Access Compliance Report

Public Rights-of-Way

(Curb Ramps)

Intersection ID: 10035679	Main Street: RED_RUST_LN	Cross Street: N/A	Location: W
ADA ID: CBD0B98A50C6	Ramp Type: Perp	Initial Pass/Fail: Fail	Overall Compliance: No
Severity Score: 12.5			
Codes/Mitigation Info/Possible Solution		Field Measurements/Component Compliance

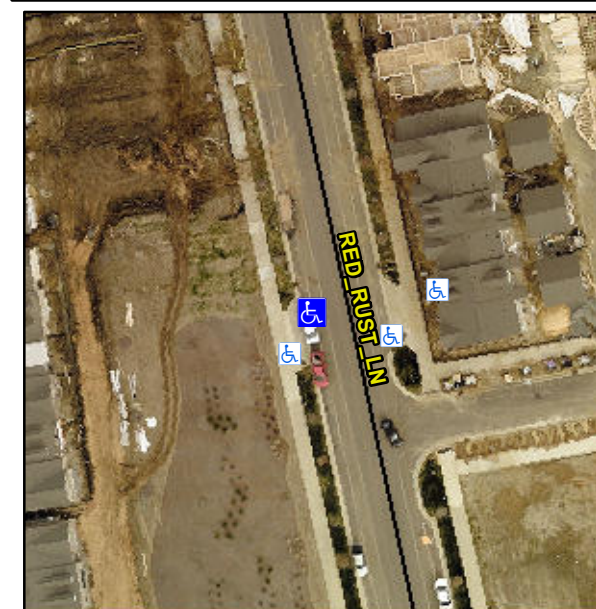
R304.5.3

Compliance	Description	Data	Compliance	Description	Data
N/A	Ramp Length (in)	57.0	Yes	Ramp Slope (%)	6.5
Yes	Ramp Width (in)	59.0	No	Ramp XSlope (%)	5.3
N/A	Flare Type LT	N/A	N/A	Flare Type RT	N/A
N/A	Flare Slope LT (%)	N/A	N/A	Flare Slope RT (%)	N/A
N/A	Flare Traversable LT?	N/A	N/A	Flare Traversable RT?	N/A
N/A	Landing Length (in)	N/A	N/A	DWS Provided?	N/A
N/A	Landing Width (in)	N/A	N/A	DWS Contrast?	N/A
N/A	Landing Slope (%)	N/A	N/A	DWS Length (in)	N/A
N/A	Landing X Slope (%)	N/A	N/A	DWS Full Width?	N/A
N/A	Landing Curb? (Y/N)	N/A	N/A	DWS Offset (in)	N/A
N/A	Shared Landing?	N/A			
N/A	Gutter Ponding?	N/A	N/A	Gutter Slope (%)	N/A
N/A	Gutter Lip Ht (in)	N/A	N/A	Gutter X Slope (%)	N/A
N/A	Painted X Walk1?	No	N/A	Painted X Walk2?	N/A
	X Walk 1 Direction	To E		X Walk 2 Direction	N/A
N/A	X Walk 1 Width (in)	N/A	N/A	X Walk 2 Width (in)	N/A
	X Walk 1 Slope (%)	2.1		X Walk 2 Slope (%)	N/A
	X Walk 1 X Slope (%)	1.1		X Walk 2 X Slope (%)	N/A

Remove & Replace Entire Ramp.
